# Access Compliance Report

## Public Rights-of-Way

### (Curb Ramps)

Intersection ID: 10015273	Main Street: E_12TH_ST	Cross Street: N/A	Location: N
ADA ID: 7E788C2E97F0	Ramp Type: Para	Initial Pass/Fail: Fail	Overall Compliance: No
		Severity Score: 12.5

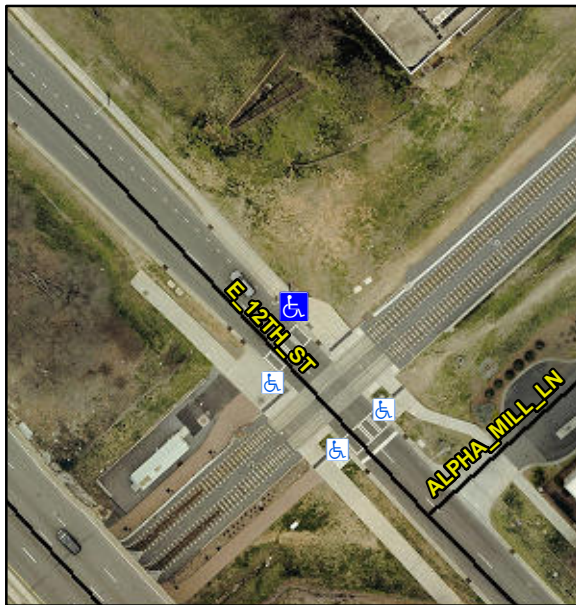
**R304.3.2**

Compliance	Description	Data	Compliance	Description	Data
N/A	Ramp Length LT (in)	71.5	N/A	Ramp Length RT (in)	72.0
Yes	Ramp Width LT (in)	83.0	Yes	Ramp Width RT (in)	83.0
Yes	Ramp Slope LT (%)	6.1	No	Ramp Slope RT (%)	8.7
Yes	Ramp XSlope LT (%)	0.5	Yes	Ramp XSlope RT (%)	0.8
N/A	Landing Length (in)	N/A	N/A	DWS Provided?	N/A
N/A	Landing Width (in)	N/A	N/A	DWS Contrast?	N/A
N/A	Landing Slope (%)	N/A	N/A	DWS Length (in)	N/A
N/A	Landing X Slope (%)	N/A	N/A	DWS Full Width?	N/A
N/A	Landing Curb? (Y/N)	N/A	N/A	DWS Offset (in)	N/A
N/A	Shared Landing?	N/A			
N/A	Gutter Ponding?	N/A	N/A	Gutter Slope (%)	N/A
N/A	Gutter Lip Ht (in)	N/A	N/A	Gutter X Slope (%)	N/A
N/A	Painted X Walk1?	Yes	N/A	Painted X Walk2?	N/A
	X Walk 1 Direction	To SW		X Walk 2 Direction	N/A
N/A	X Walk 1 Width (in)	87.0	N/A	X Walk 2 Width (in)	N/A
	X Walk 1 Slope (%)	1.5		X Walk 2 Slope (%)	N/A
	X Walk 1 X Slope (%)	1.9		X Walk 2 X Slope (%)	N/A
N/A	Ramp inside XWalk1?	Yes	N/A	Ramp inside XWalk2?	N/A

**Remove & Replace Entire Ramp.**
